NOTICE OF A TYPE II DECISION ON A PROPOSAL IN YOUR NEIGHBORHOOD

CASE FILE NUMBER: LU 14-112435 DZ

New Overhead Door on South Façade of Mead Building

Exhibit C-1

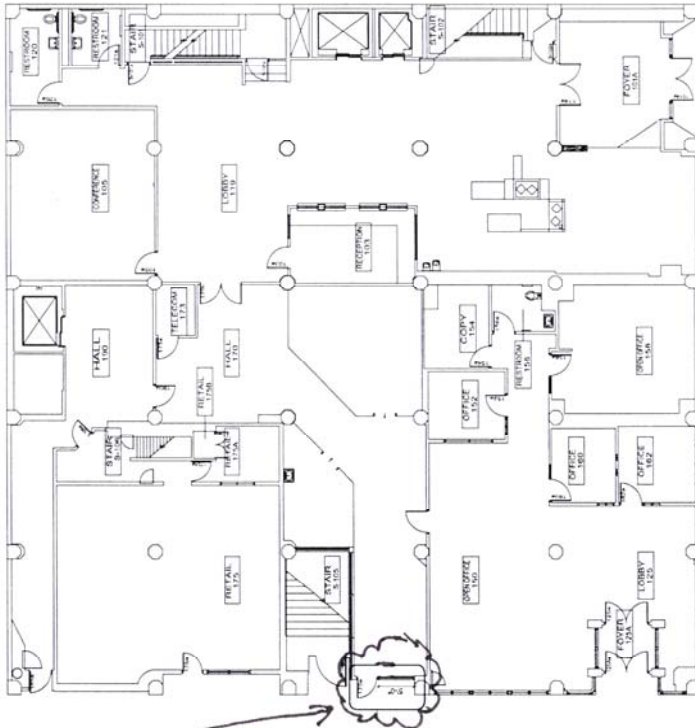
Findings for A8 and C9: Because the new overhead door is glazed instead of solid, it maintains visual transparency at the ground floor of the building. This allows for a visual connection between the private space of the building and the public space of the abutting sidewalk, and it maintains the building's flexibility to accommodate a variety of active uses in the future. *Therefore these guidelines are met.*

Findings for B2: The proposed overhead door is being installed to allow for easier transport of trash receptacles into and out of the building's ground-floor trash room. The use of a glazed overhead door instead of a solid overhead door minimizes adverse visual effects on the abutting pedestrian environment. *Therefore this guideline is met.*

Approval to remove an existing double-door entry, transom windows, and sidelight and replace them with a glazed overhead door and new transom windows, located on the south facade of the Mead building located in the Downtown Subdistrict of the Central City Plan District.

Approval per the approved plans and drawings, Exhibits C-1 through C-4, signed and dated April 22, 2014, subject to the following condition:
